# 101 Camley Street, Camden

NMA Design Statement to the London Borough of Camden  
November 2019

This document has been produced in order to update London Borough of Camden on changes to the design of specific elements since the Section 73 NMA Application was submitted in November 2018.

North Elevation. Scale 1:400 at A3.

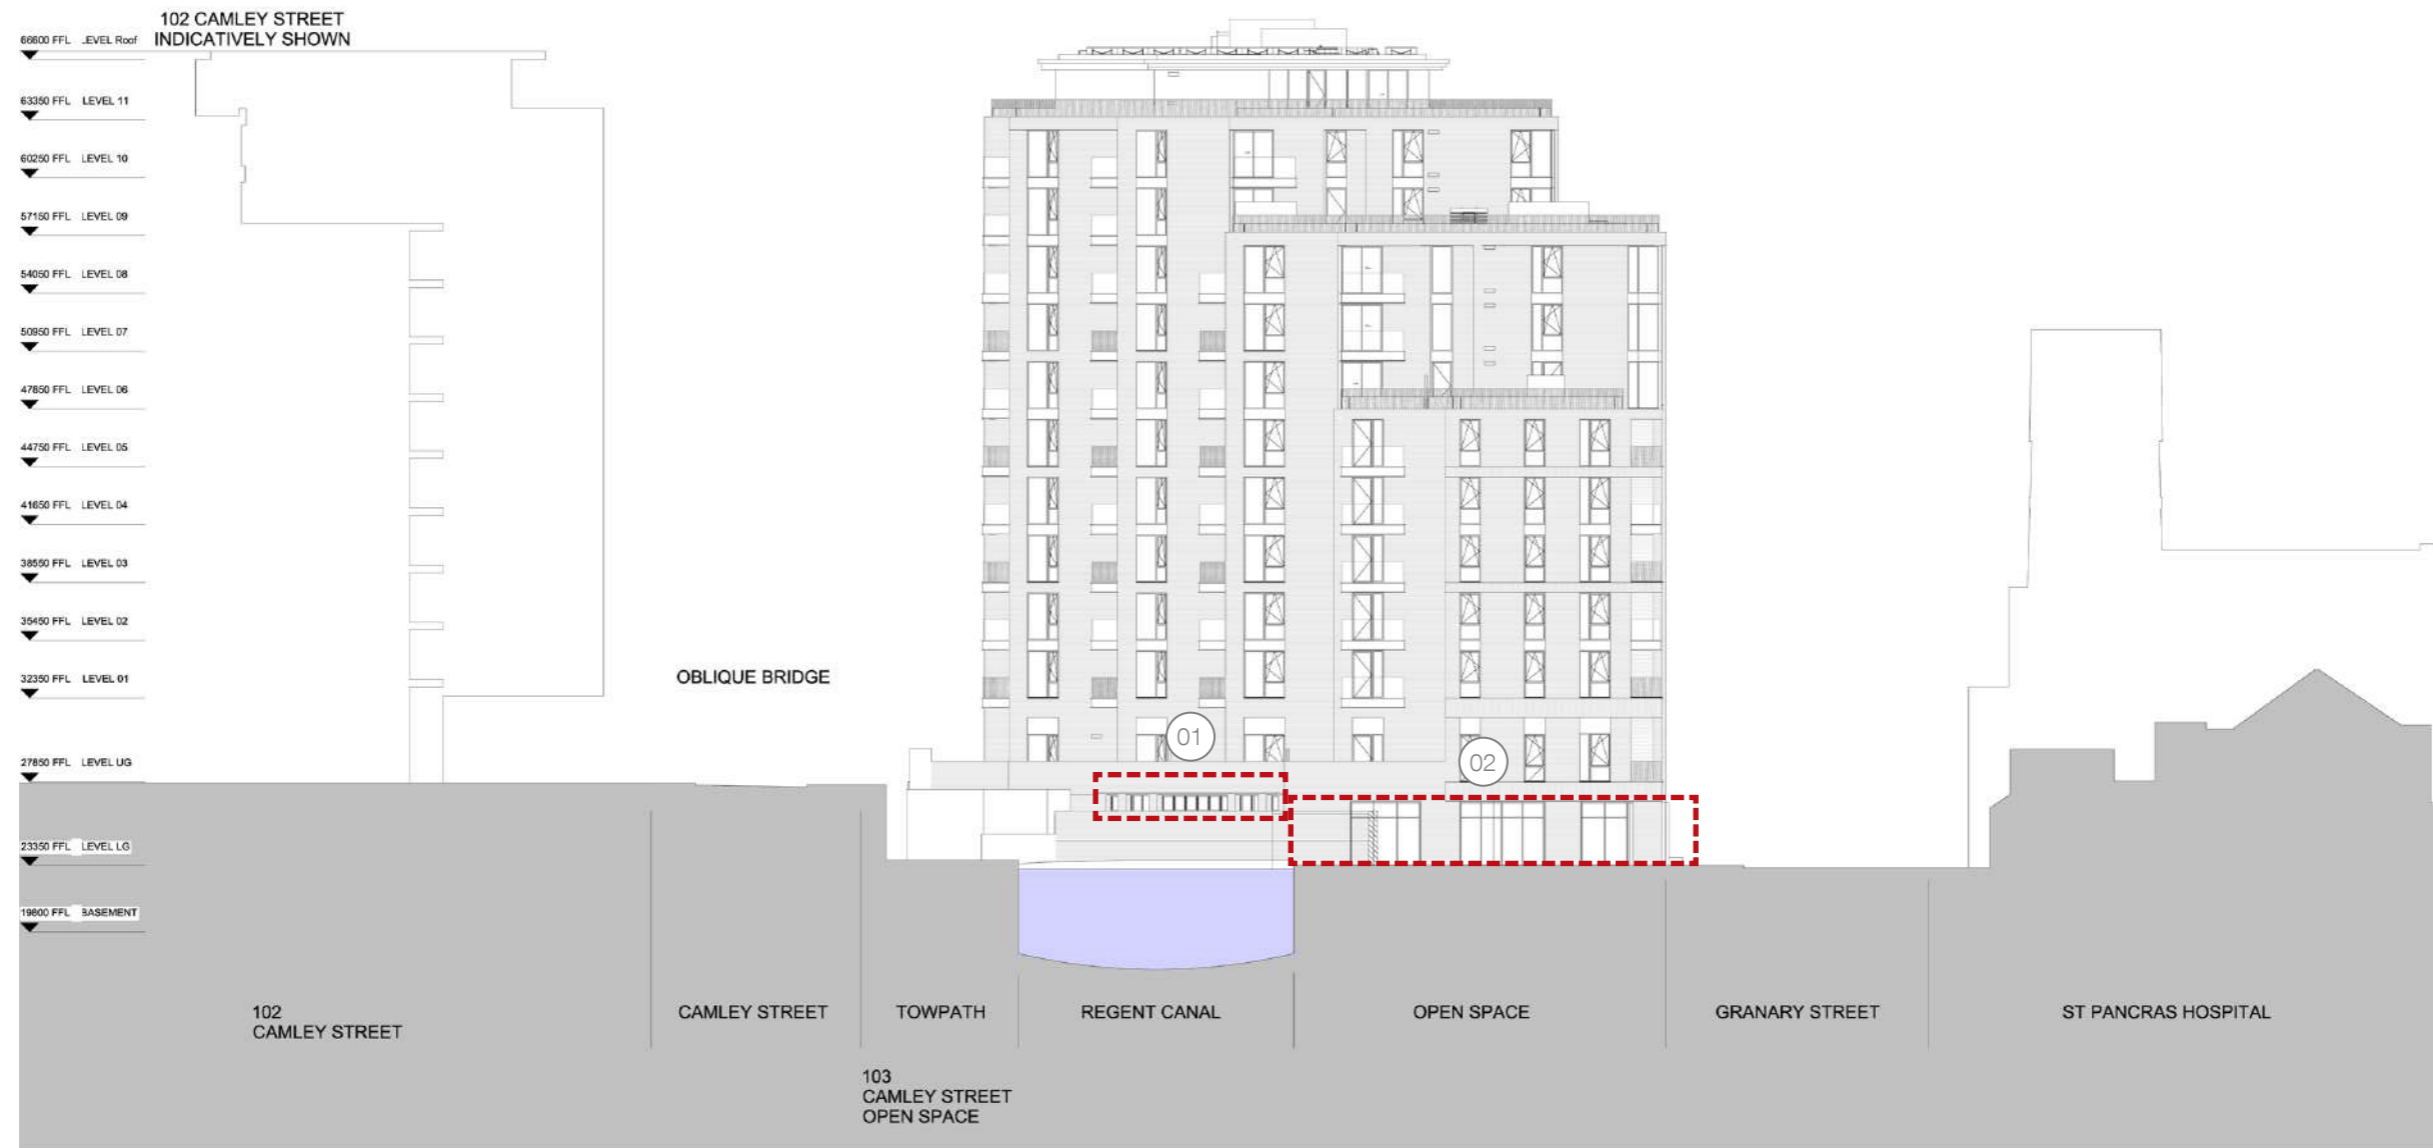
01. Area of change to design of glazing at lower ground floor level commercial.

02. Area change to design of glazing elements along north elevation commercial frontage.

West Elevation. Scale 1:400 at A3.

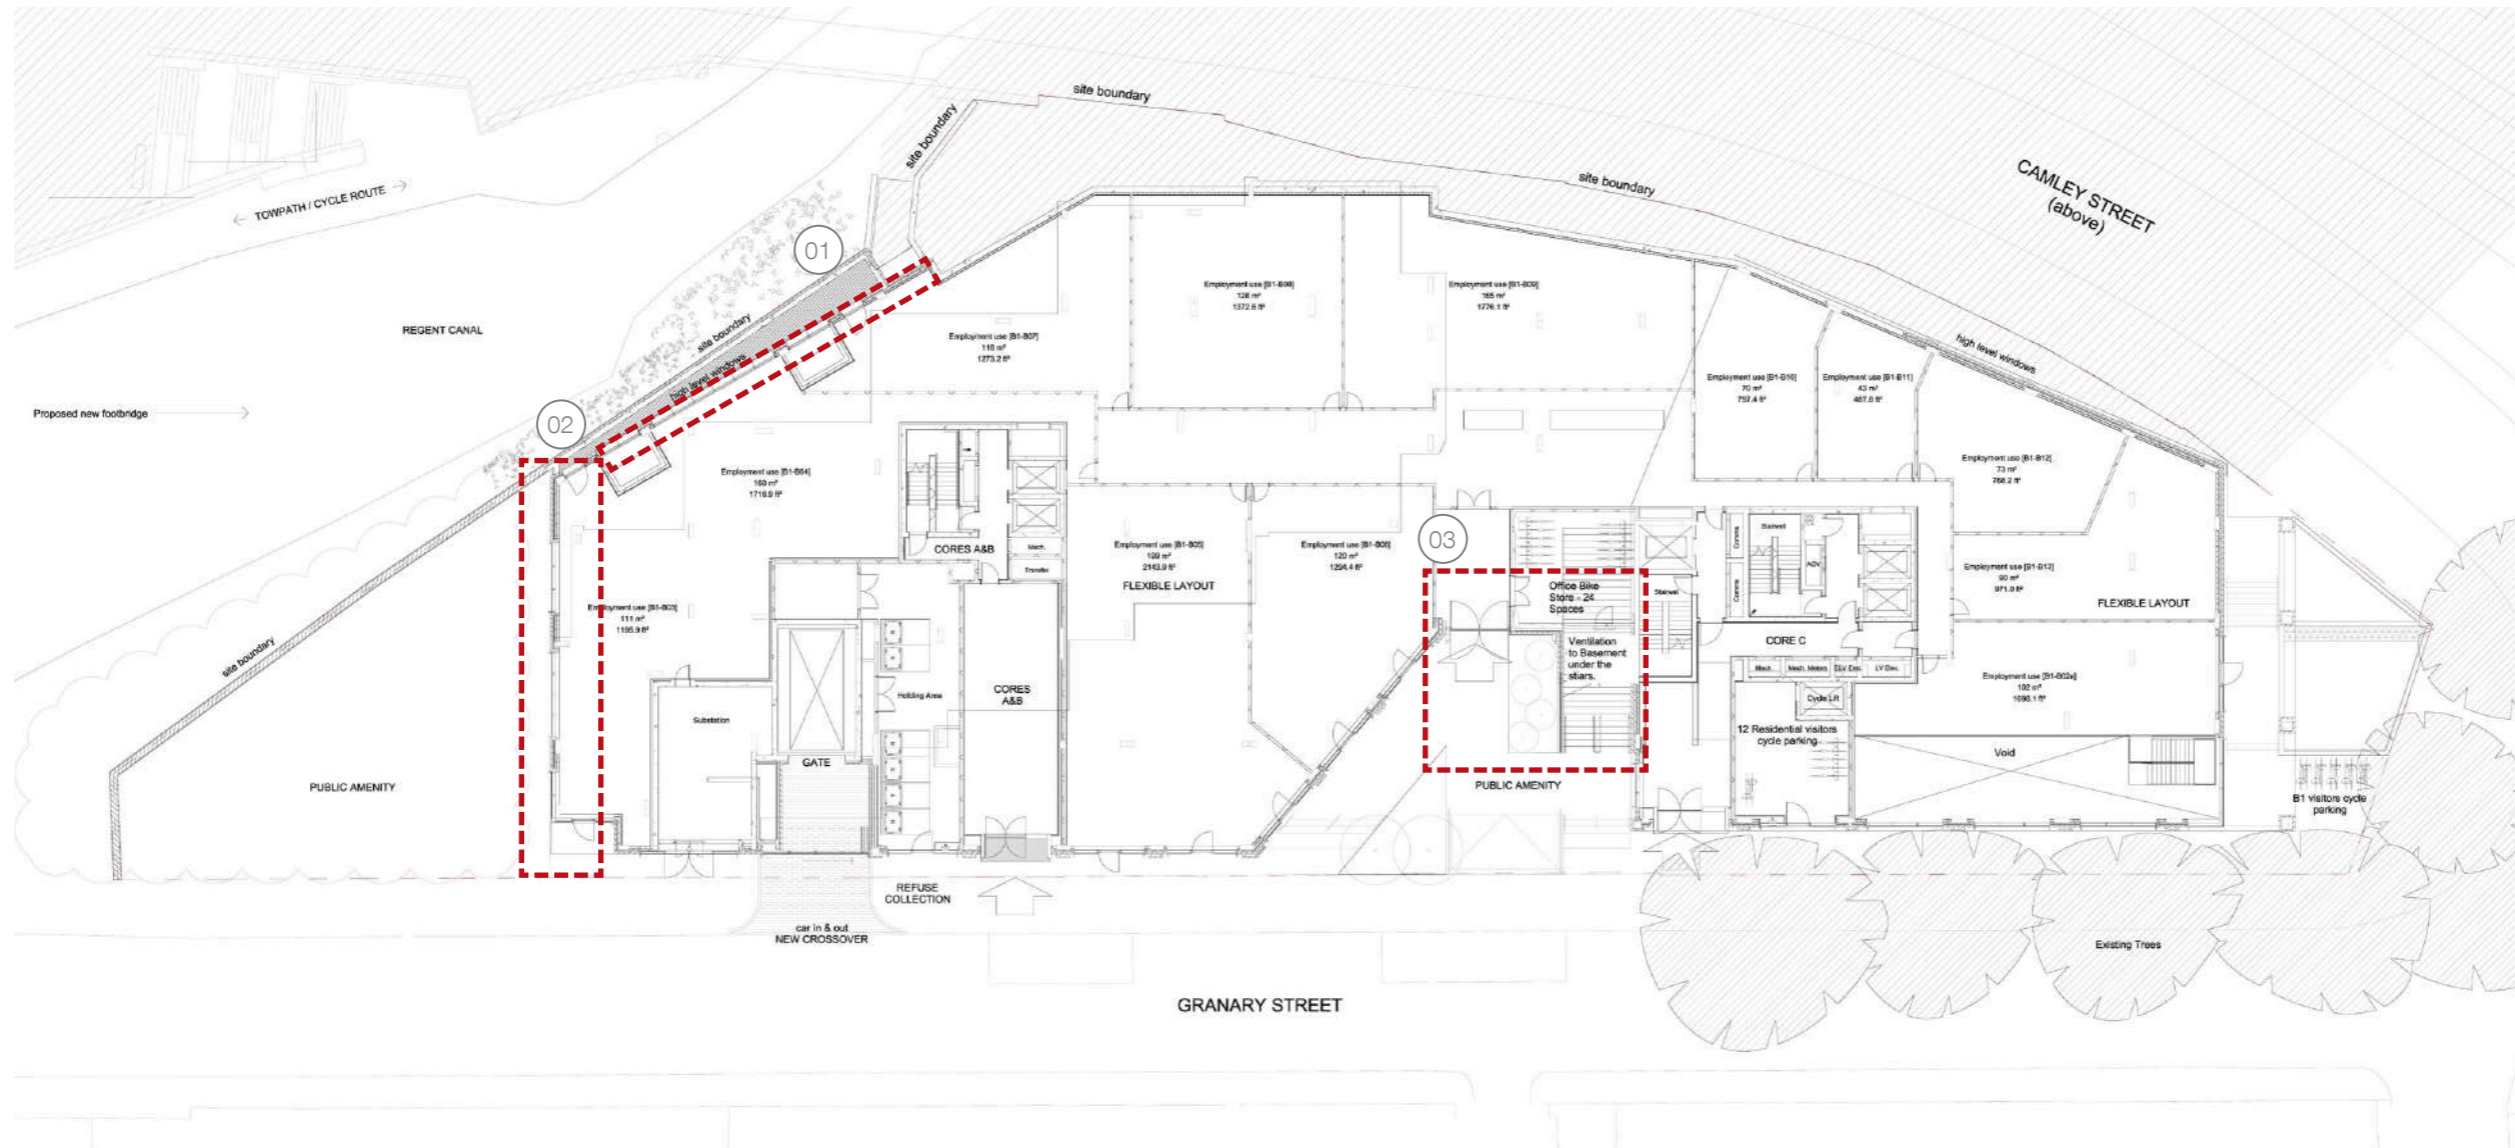
03. Area of change to Design of Portal Frame element at entrance to commercial space. Changes to Design of Balustrade and Handrail on stair and ramp at UG

# 03.01 Lower Ground Level Louvres Omitted North Elevation

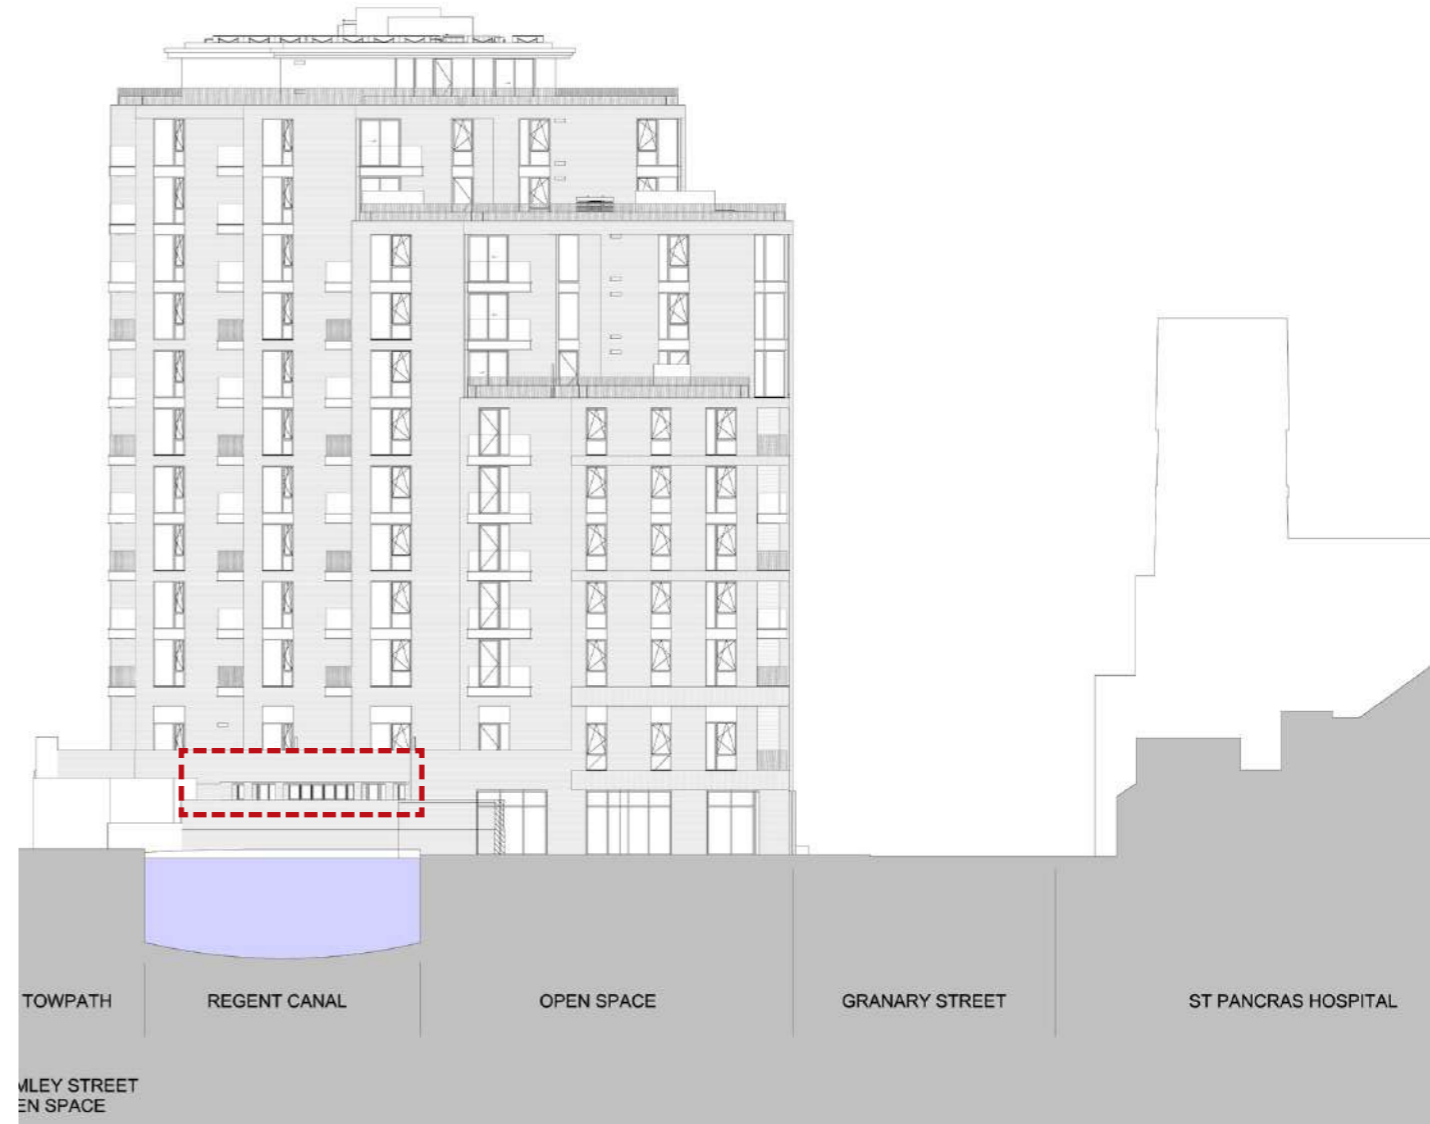
The metal louvred panels located in front of the glazing at lower ground level have been omitted. This unifies the design with other areas of the scheme and improves lighting levels within the commercial space.

- Technical Reasons for Change
- To improve light levels within the commercial area
  - To align with design across the entire scheme.

# 03.02 Lower Ground Level Commercial Glazing North Elevation

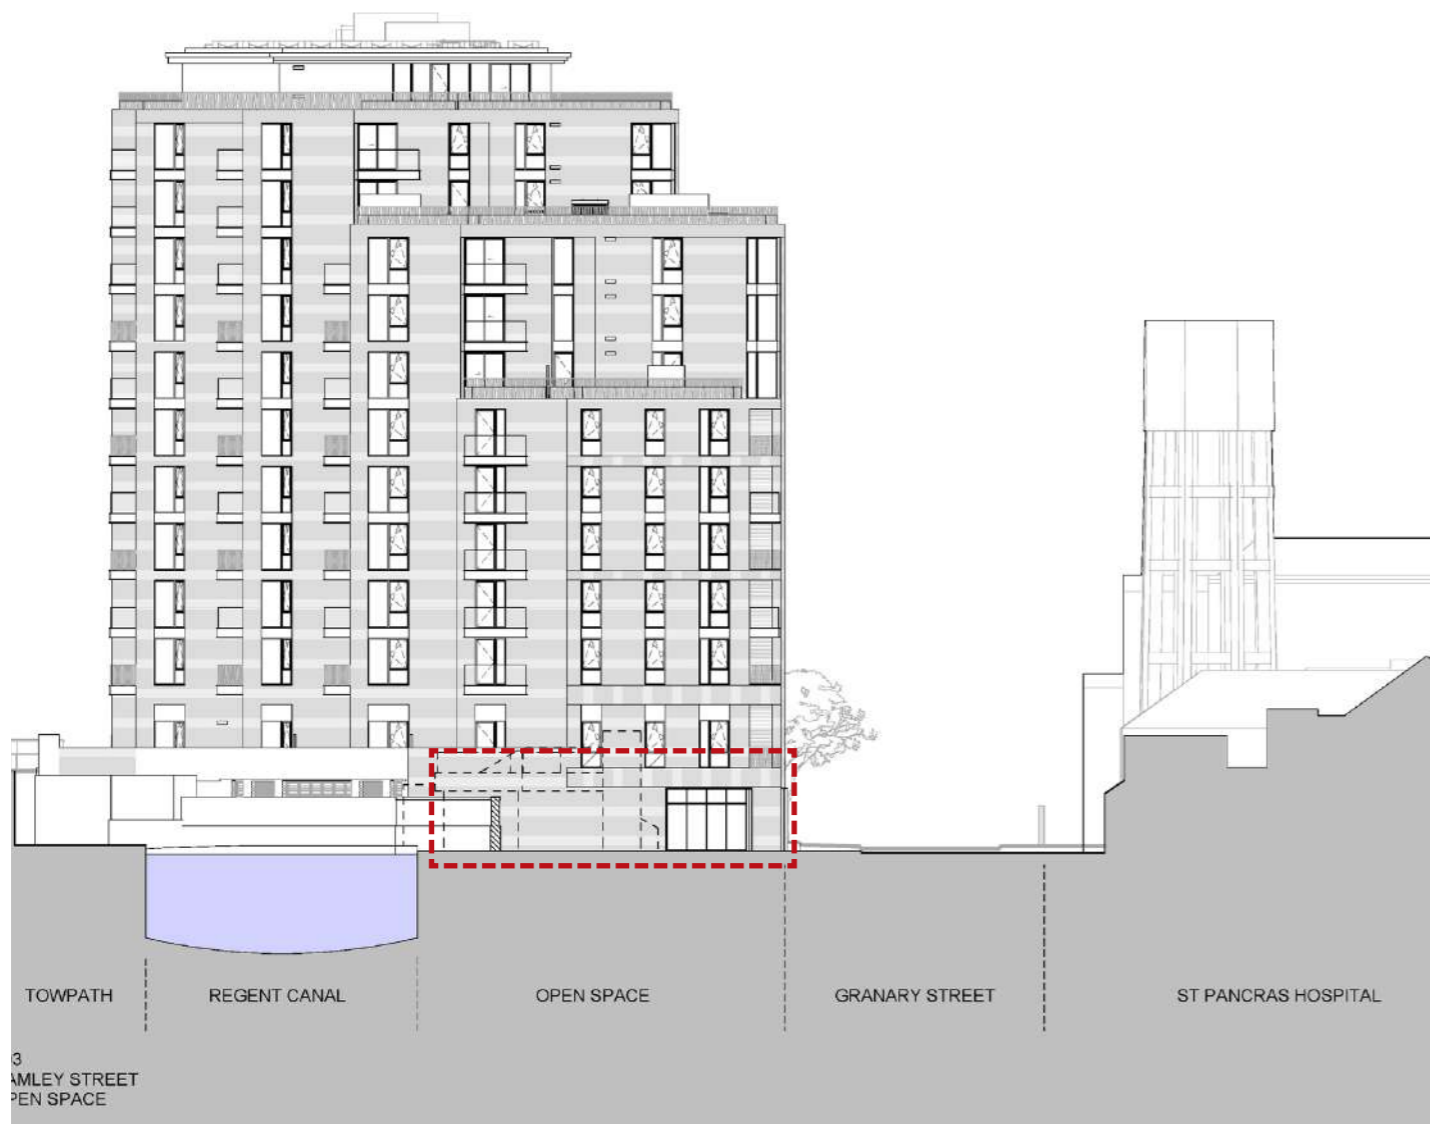
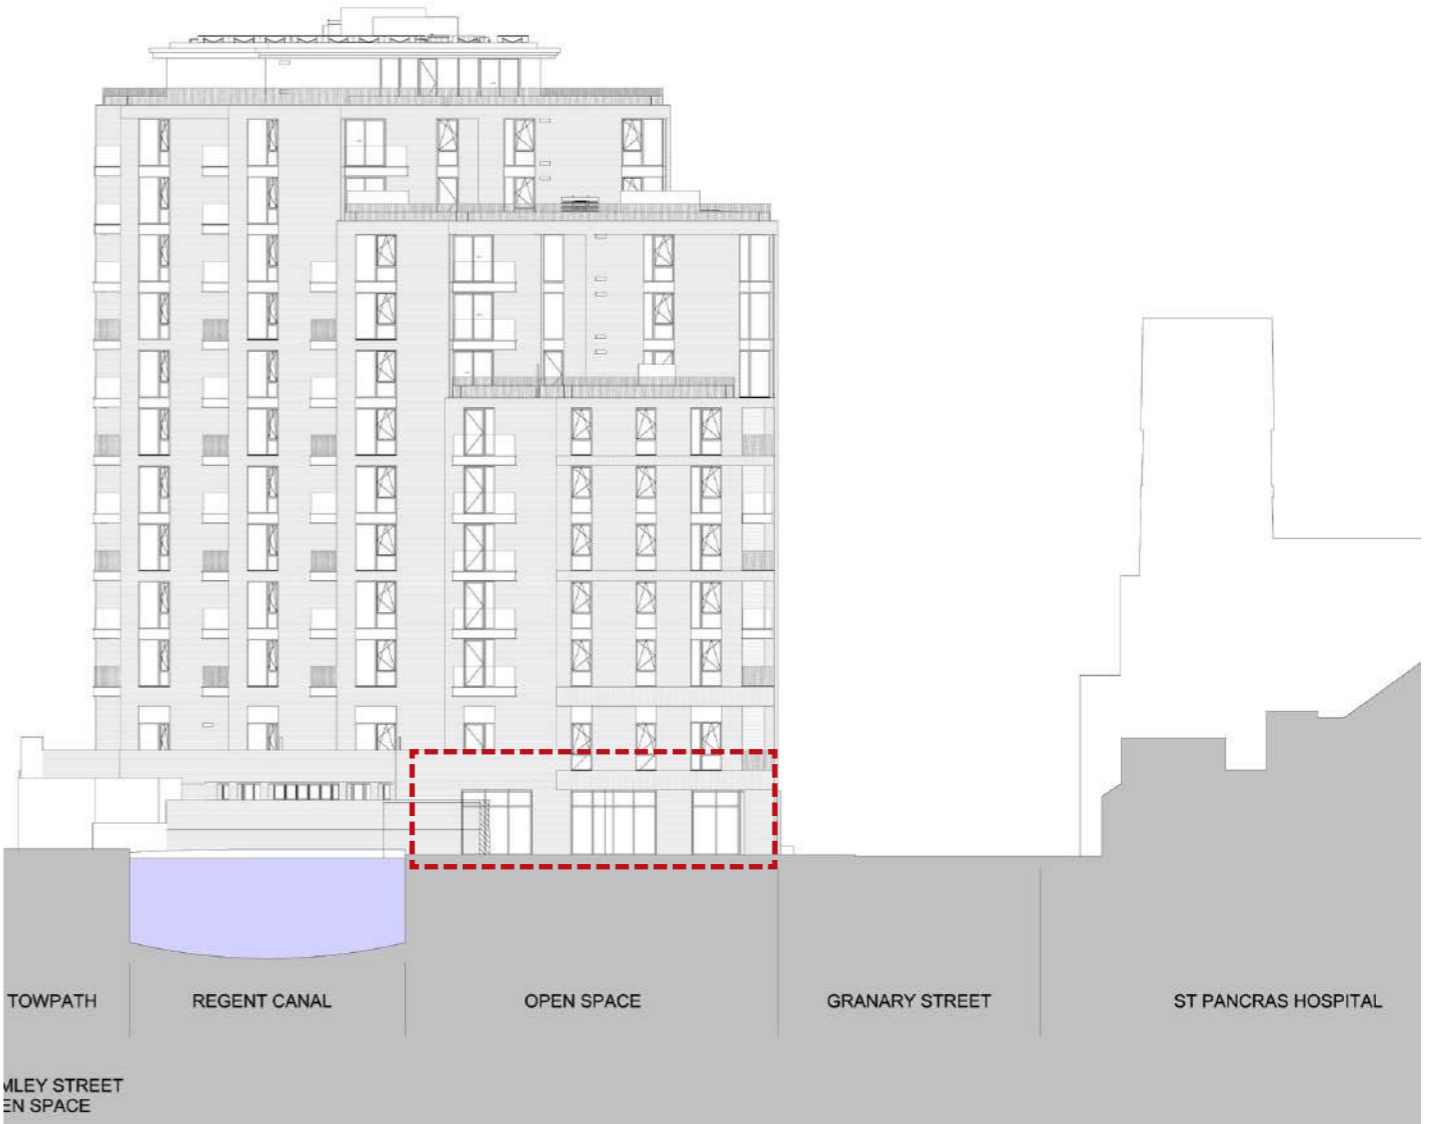
Additional openings have been created in the elevation opening onto the amenity space to the North of the site. This change improves lighting levels in the commercial space and helps to improve the visual connection between the interior commercial and amenity spaces.

- Technical Reasons for Change
- To improve light levels within the commercial area
  - To align with design across the entire scheme.
